**Annex B**

**Response to Comments on Working  
Paper**

**Subject** Scoping Study for Providing Direct Technical Remedies on Existing Flyovers - Comments on Working Paper

**Working Paper/Consultation Paper**  
**Scoping Study for Providing Direct Technical Remedies on Existing Flyovers**

FIGURE 4c - GENERIC DIRECT TECHNICAL REMEDIES FOR ROAD TRAFFIC NOISE ON FLYOVERS - FULL ENCLOSURE

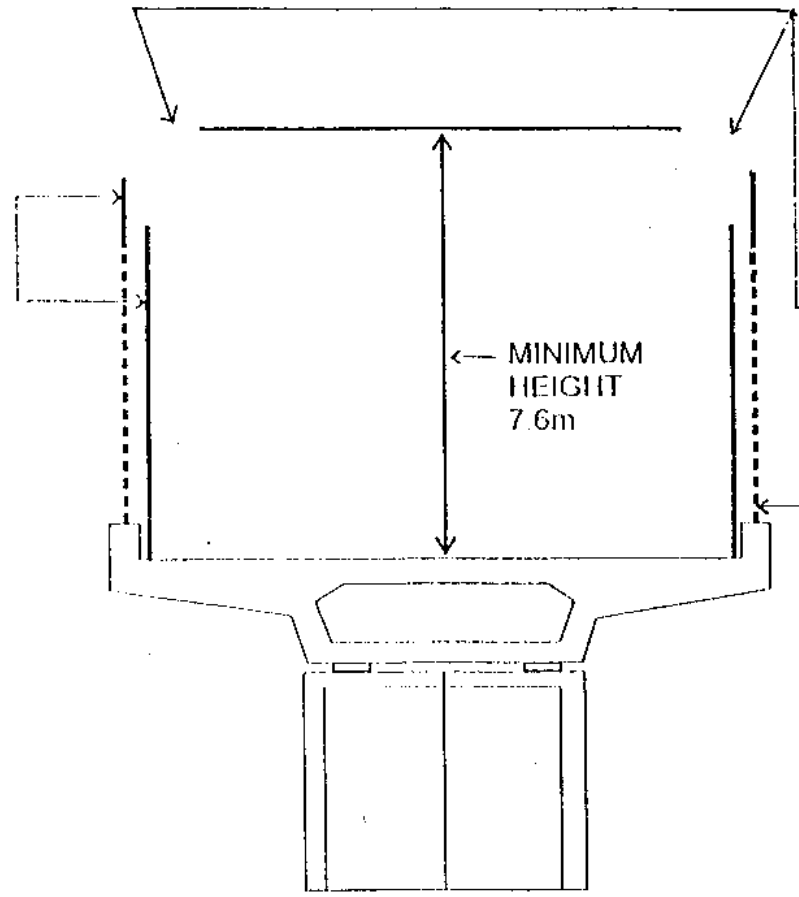
<u>Figure</u>	<u>Comment</u>
4e	In case of fire, the smoke and hot gases will go up to the highest point of the enclosure. According to your preliminary design of 6.25% open area, it will form a pocket to trap the smoke in-stead of ventilating such to open air. Therefore, the open areas must be located above the vertical acoustic panels (please see appendix I).
5a	<ul style="list-style-type: none"><li>- The minimum width of 6 m vehicular road should be indicated on the sketch (please see appendix II).</li><li>- The horizontal clearance between the outer edge of the flyover structure and building facade should be at least 4.5 m instead of 4.6 m (please see appendix II).</li></ul>

FIGURE 5a - TYPICAL ROAD - RECEIVER CONFIGURATION (EXAMPLE ONE)

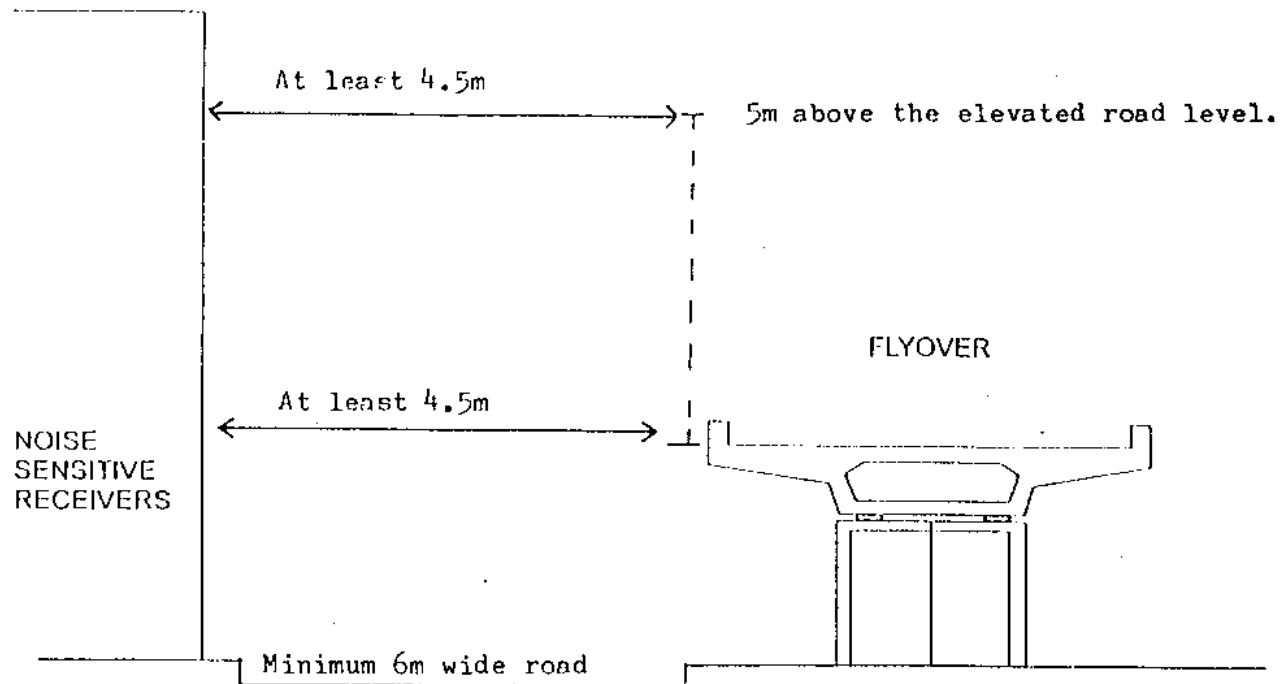
- A minimum of 4.5 m clearance between the building facade and the outer edge of 5 m above the elevated road level must be maintained (please see appendix II).

FIGURE 5b - TYPICAL ROAD - RECEIVER CONFIGURATION (EXAMPLE TWO)

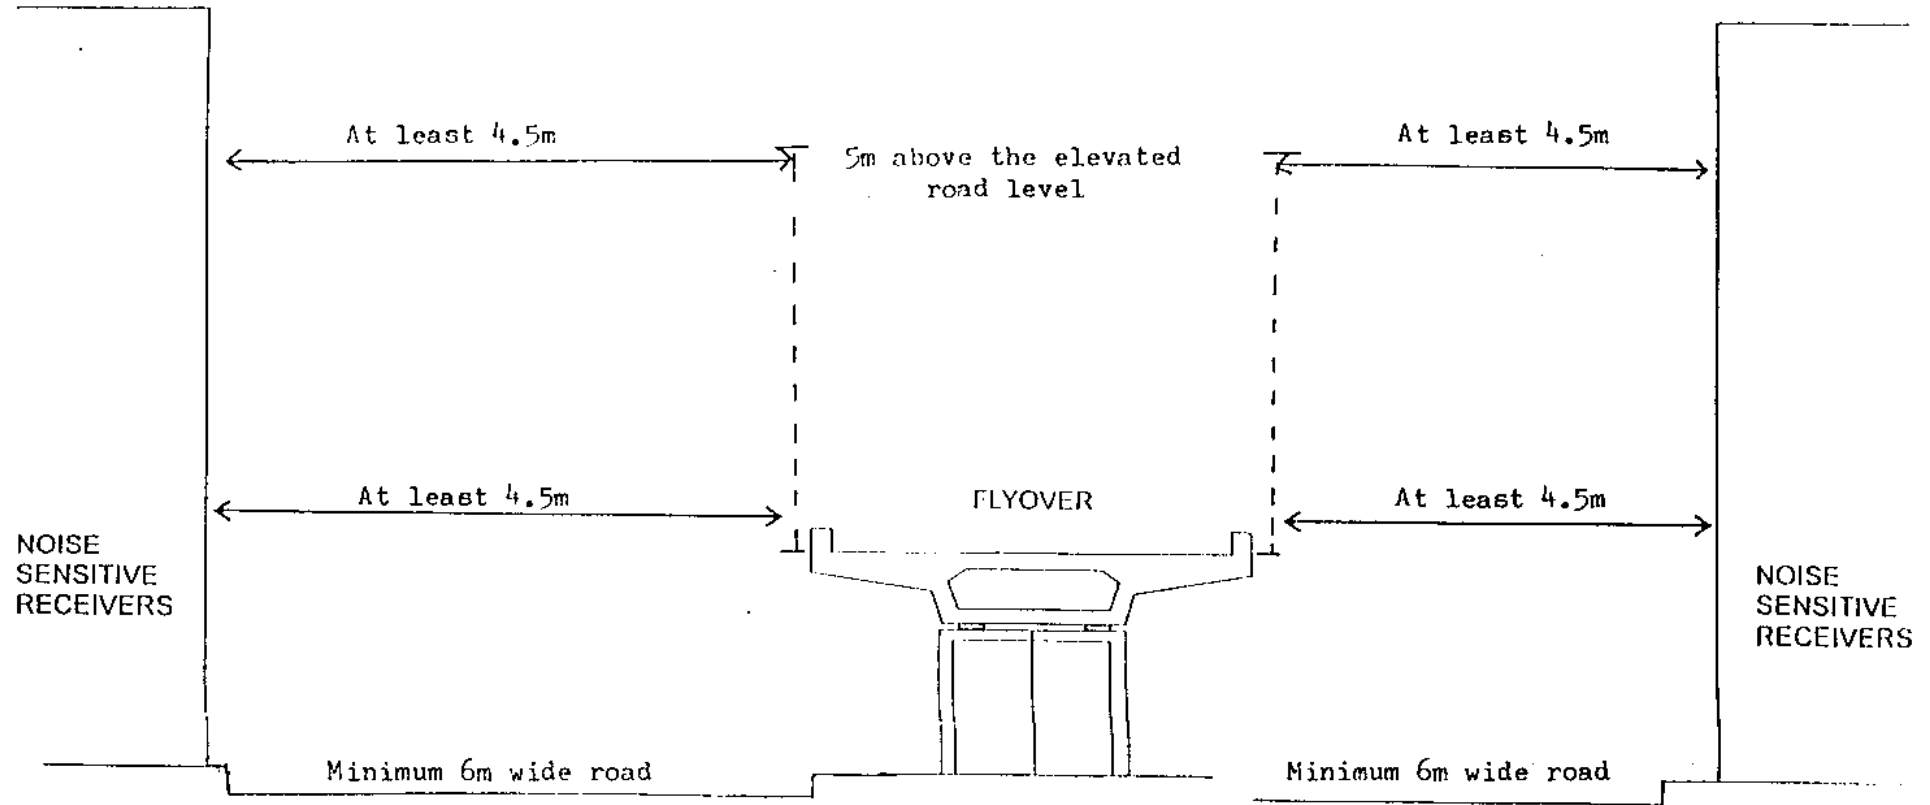
5b

----- ditto -----  
(please see appendix III)
